PLANNING COMMISSION

Monday, July 22, 2024

TO: Planning Commission
FROM: EVAN HOIER, ASSOCIATE PLANNER
DATE: July 22, 2024
SUBJECT: Mohammad Imseitef. The applicant is seeking conditional use grant approval for an automotive service facility for the property located at 10650 N. Baehr Road, Suite A-B

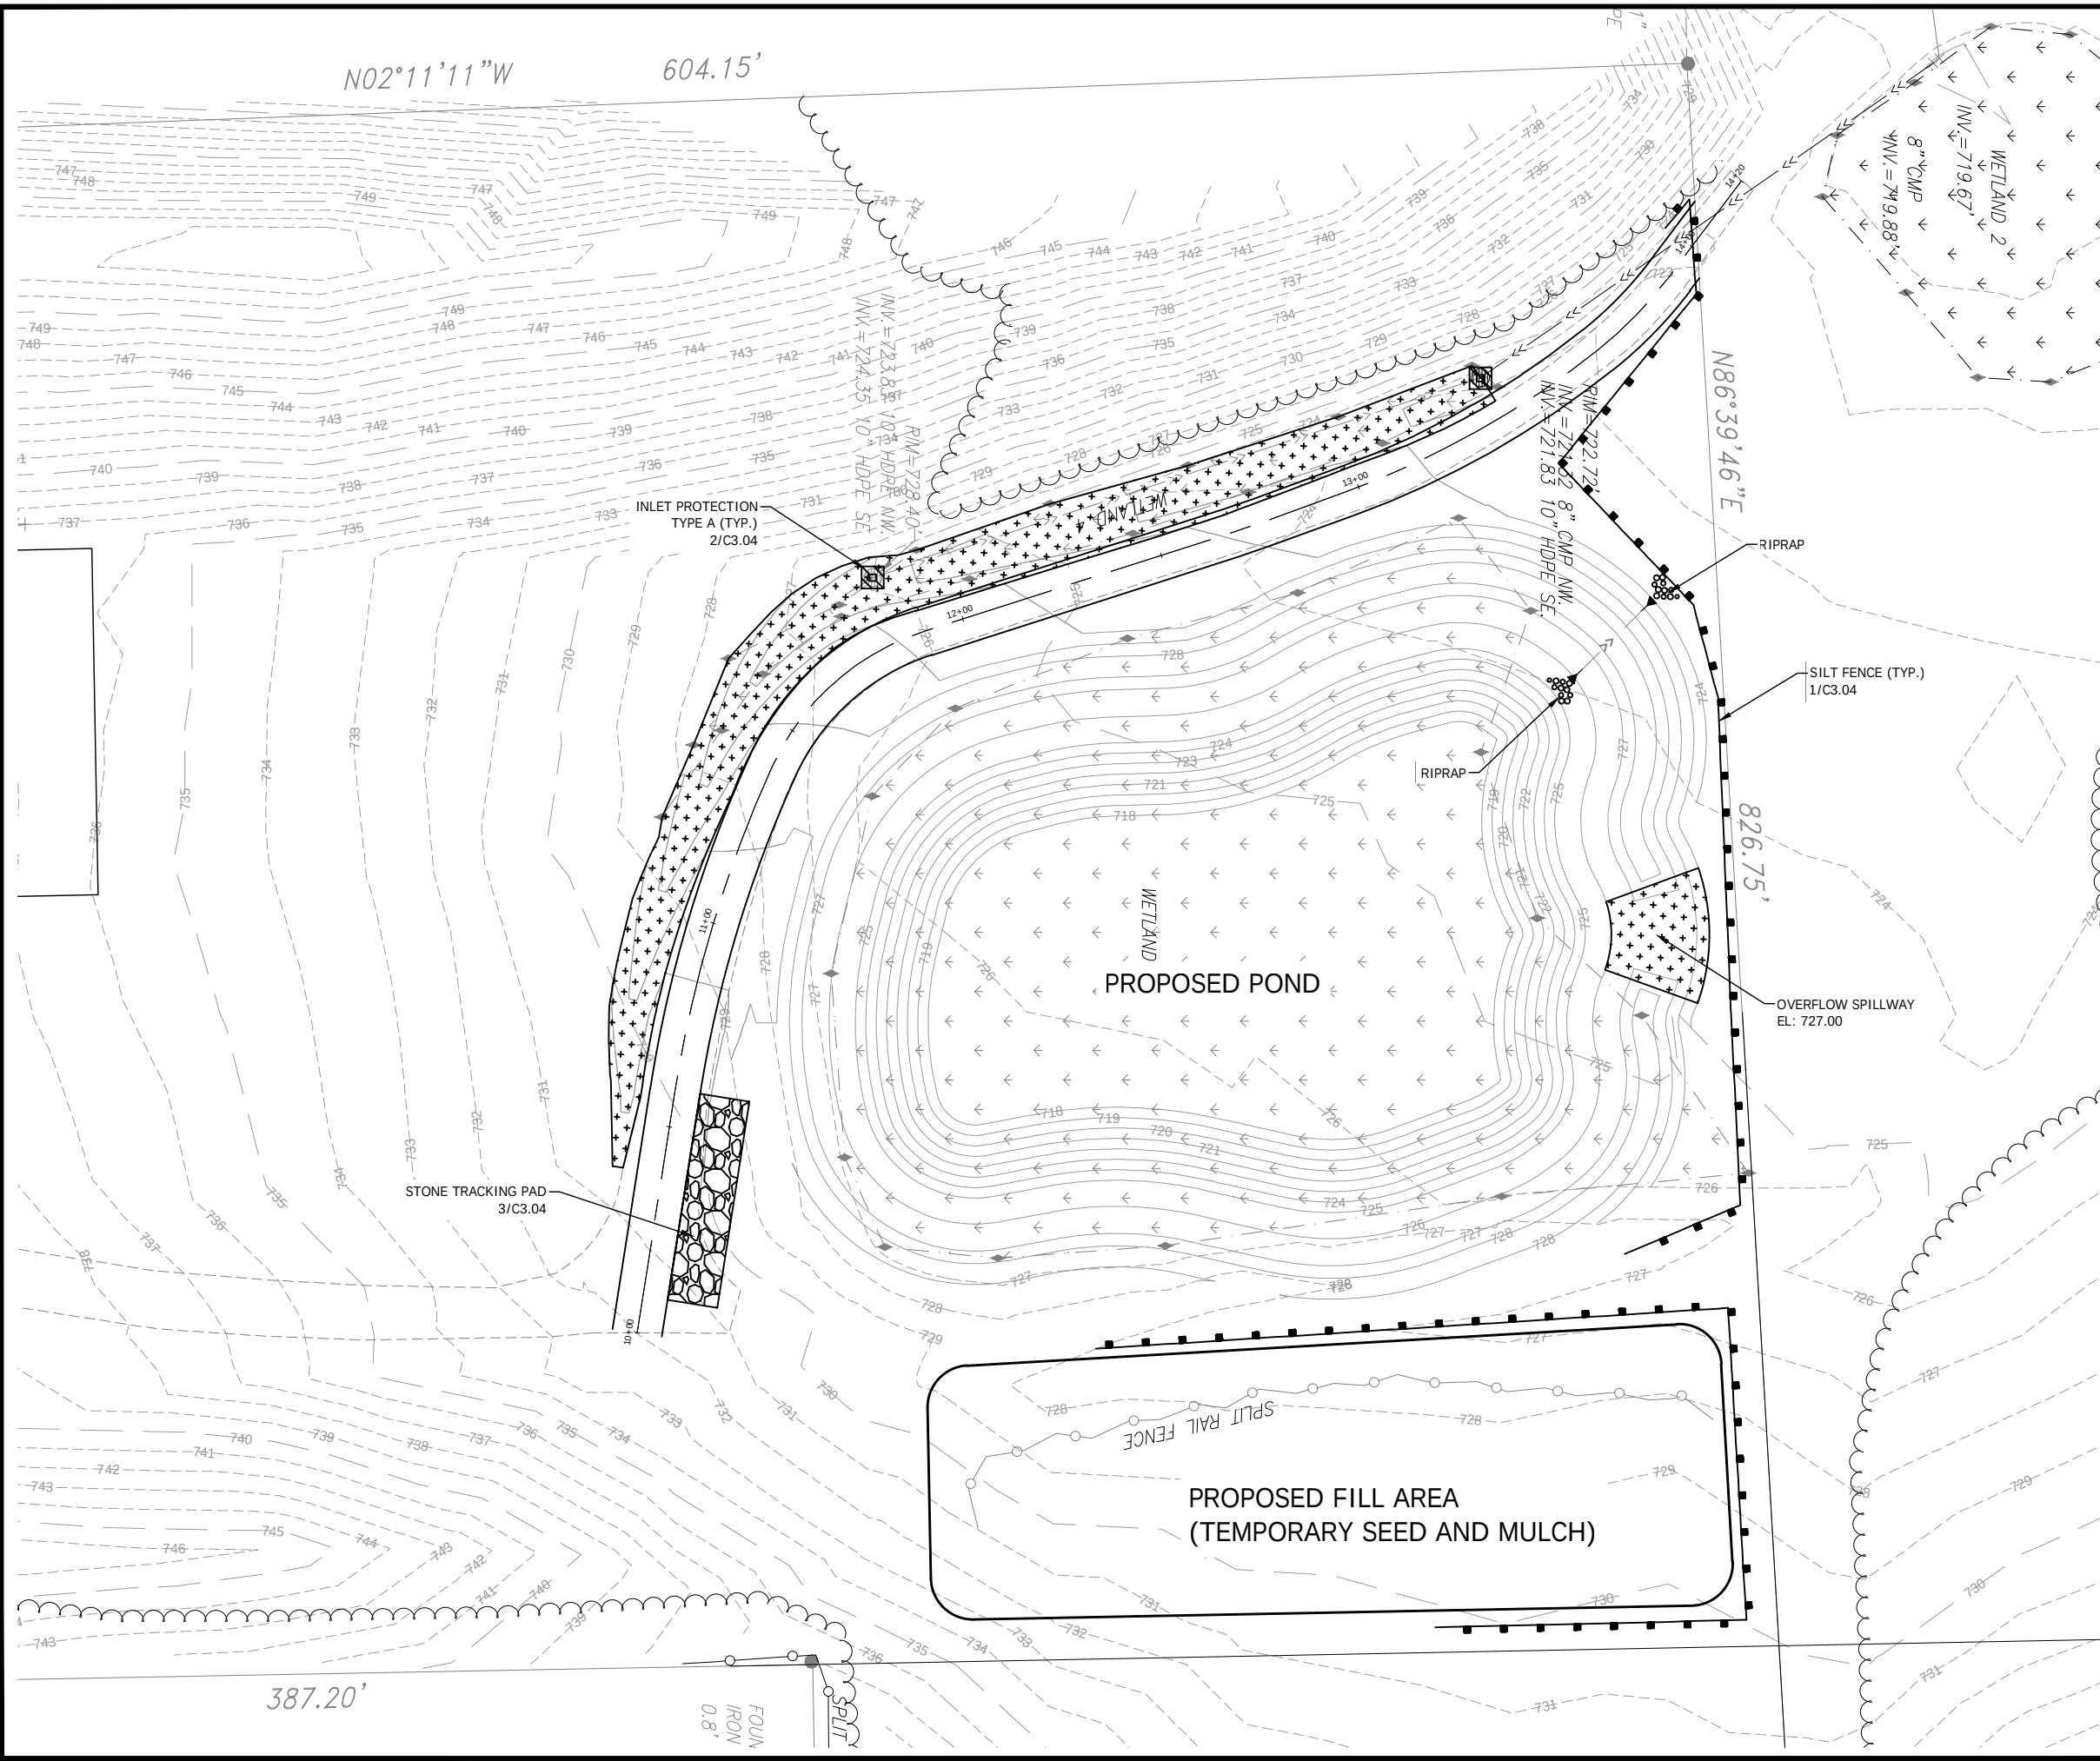
The area indicated as “proposed fill area” on sheet C2.01 does not show any elevation information. If this area is intended to be permanently filled, contours must be shown for review by engineering staff. Berms and grading must conform to the Mequon Standard Specifications for Land Development which define a maximum berm height of 4.5 feet. If this area is a temporary stockpile, proper erosion control measures must be included.
